Title & Document Type: 8405A Vector Voltmeter Operating and Service Manual

Manual Part Number: 08405-90024

Revision Date: May 1971

VECTOR VOLTMETER 8405A

Figure 7-18(b). Schematic Diagram, Power Supplies (CHANGE 17)

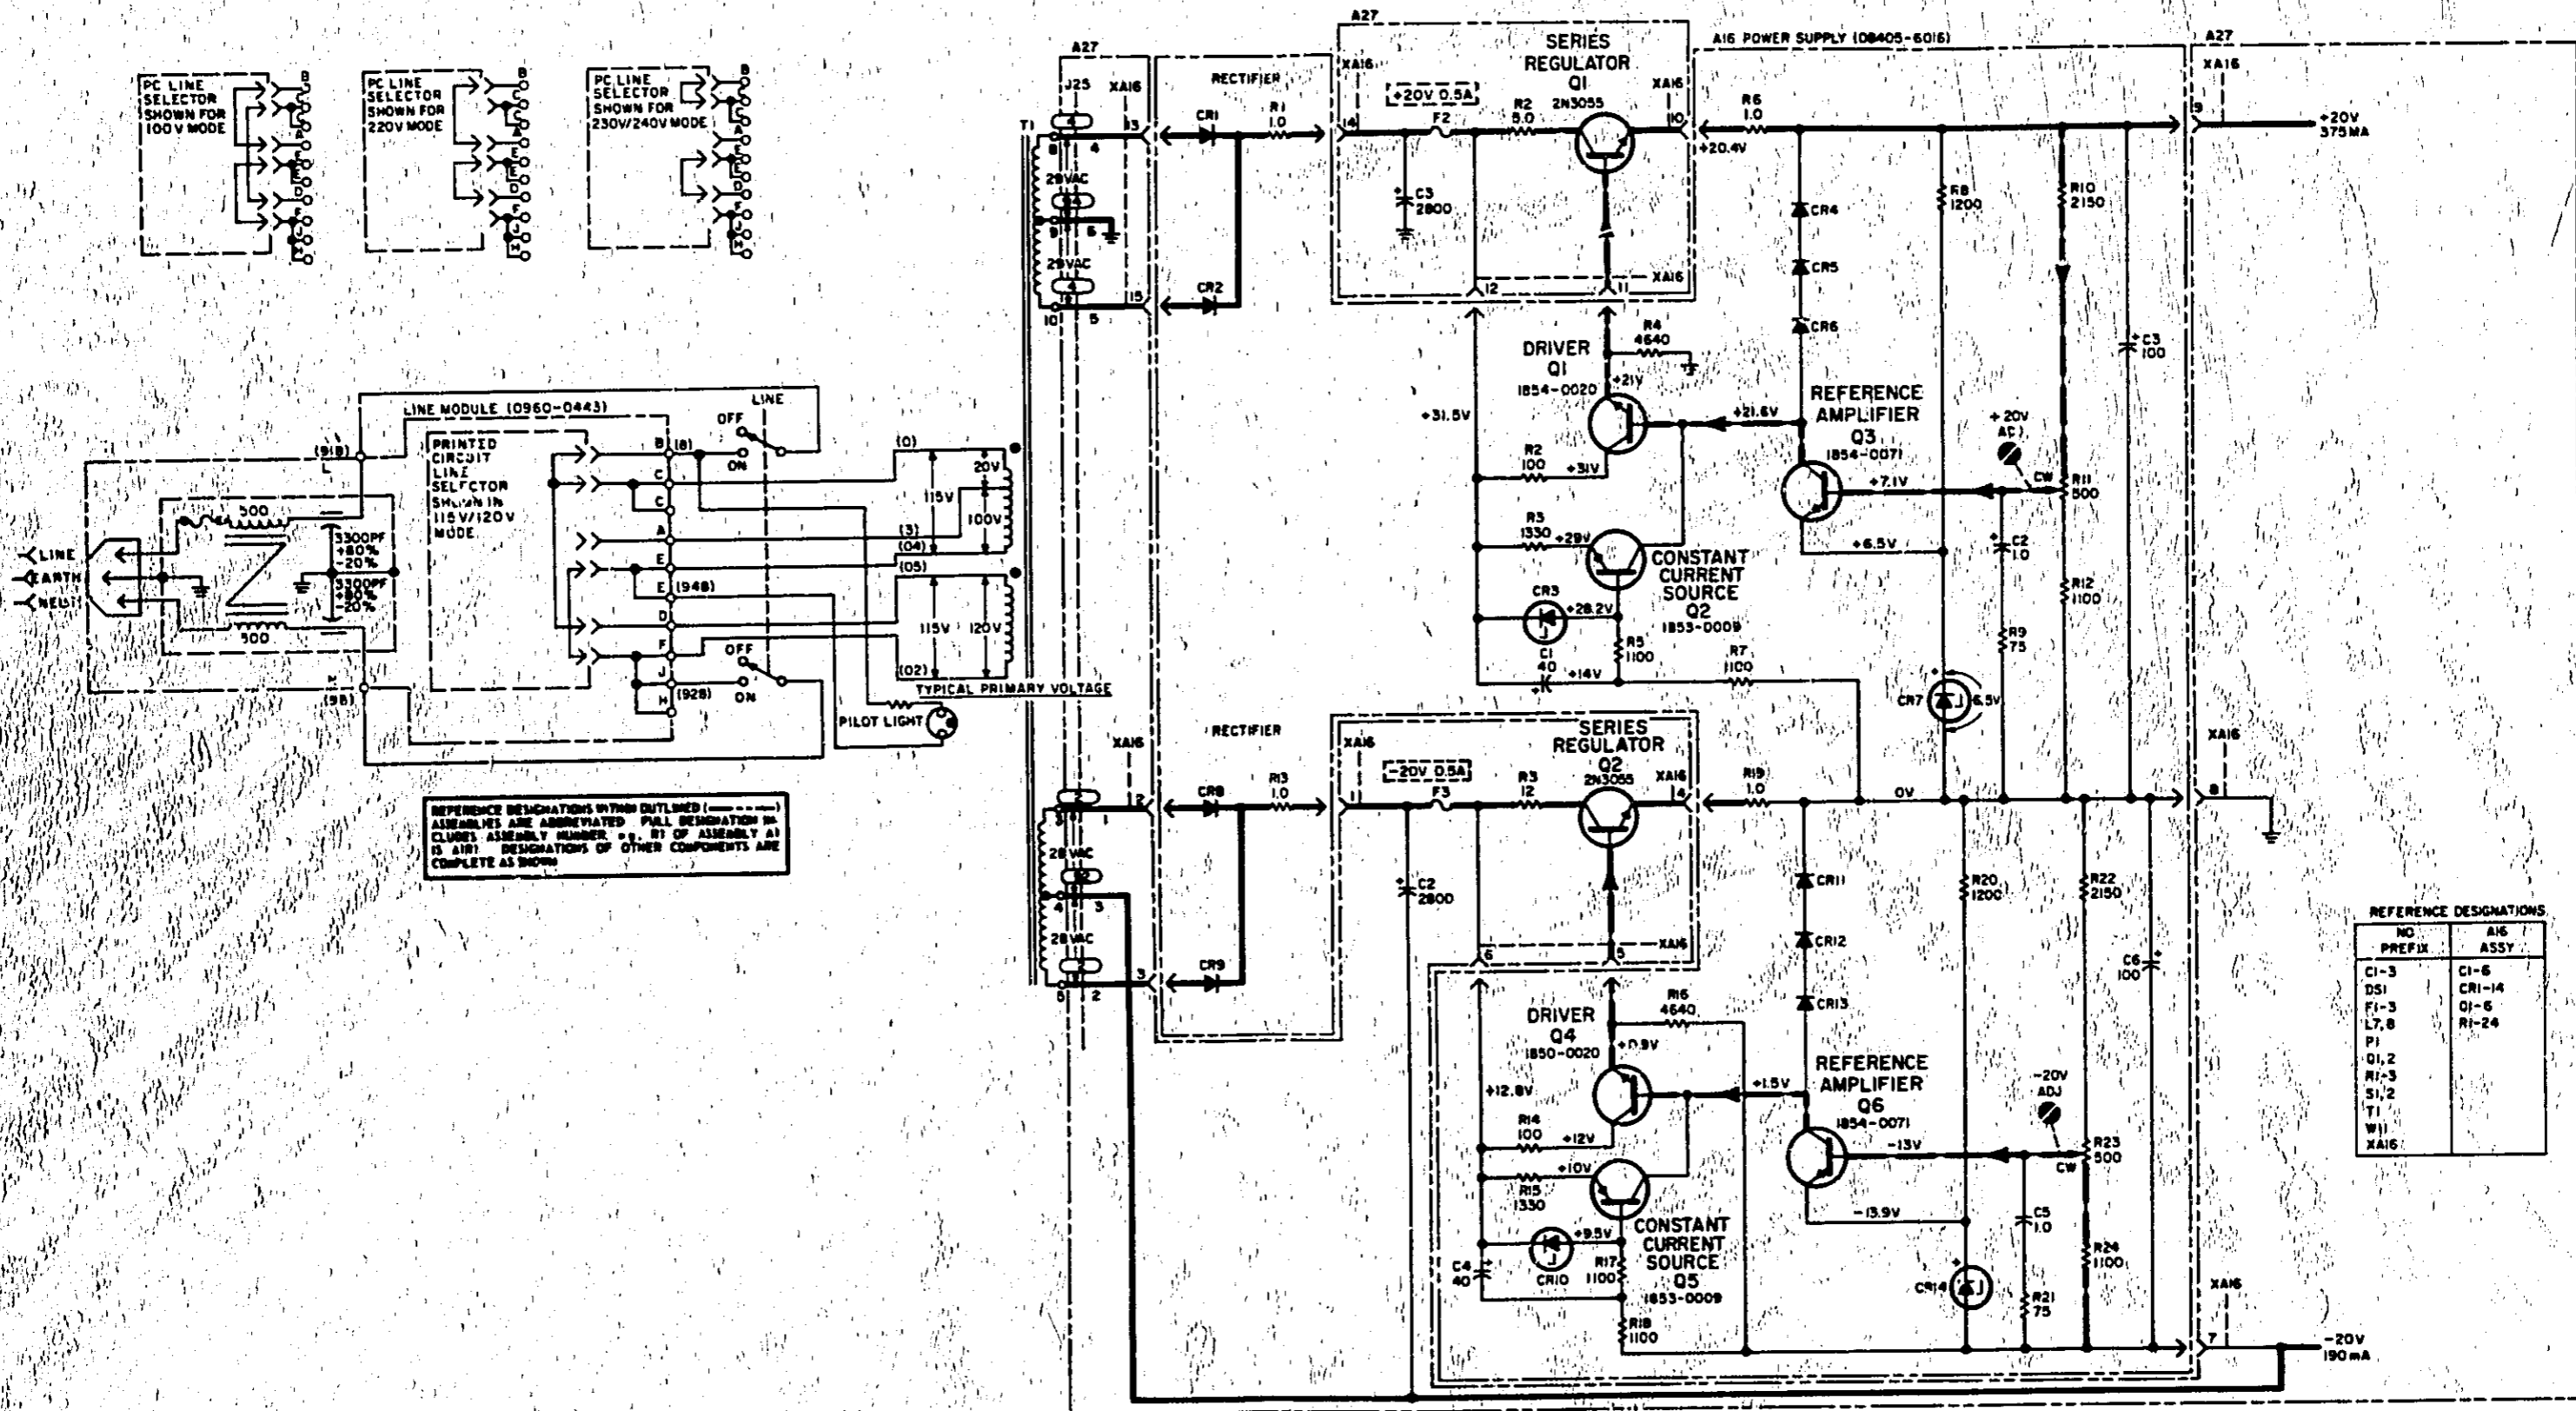
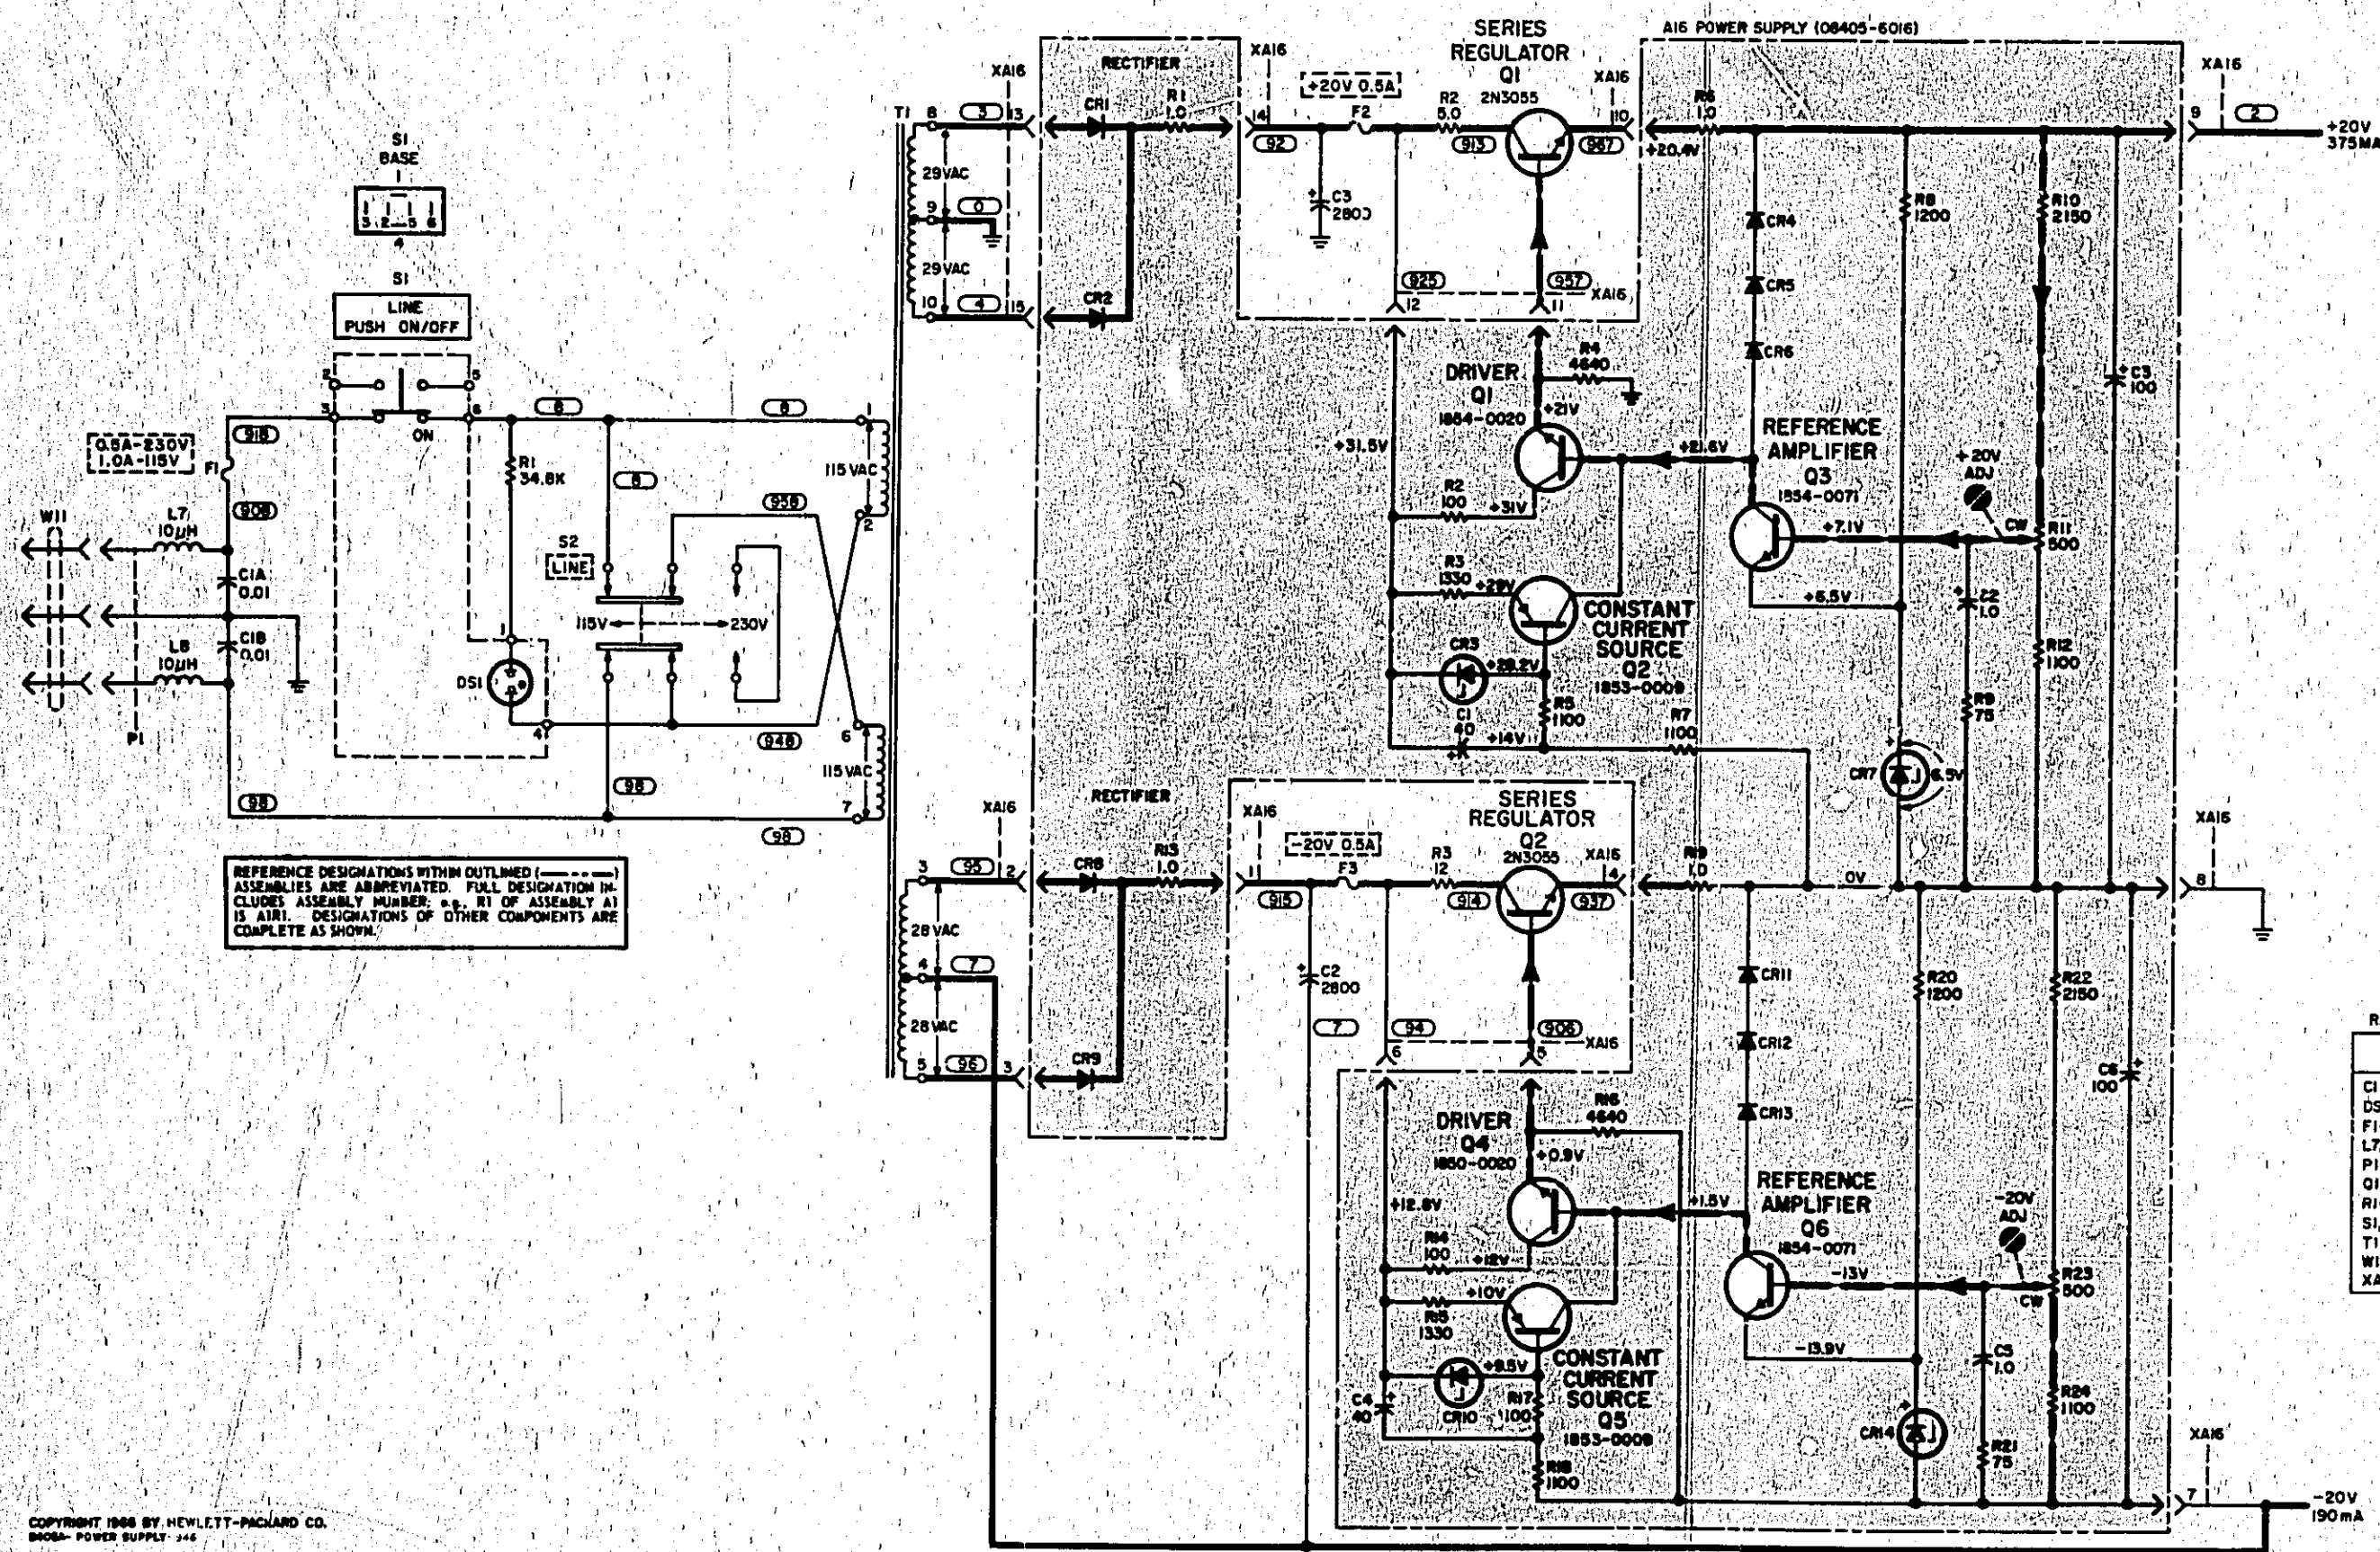
Figures 7-18(a) and 7-18(b):
Change R1 to 46.4K.

Figure 7-18(b):
Add C7. Anode to ground, cathode to base of Q5.

Figure 7-18(b):
Add A16C8, .047 uF, between anodes of CR1 and CR2.
Add A16C9, .047 uF, between anodes of CR8 and CR9.
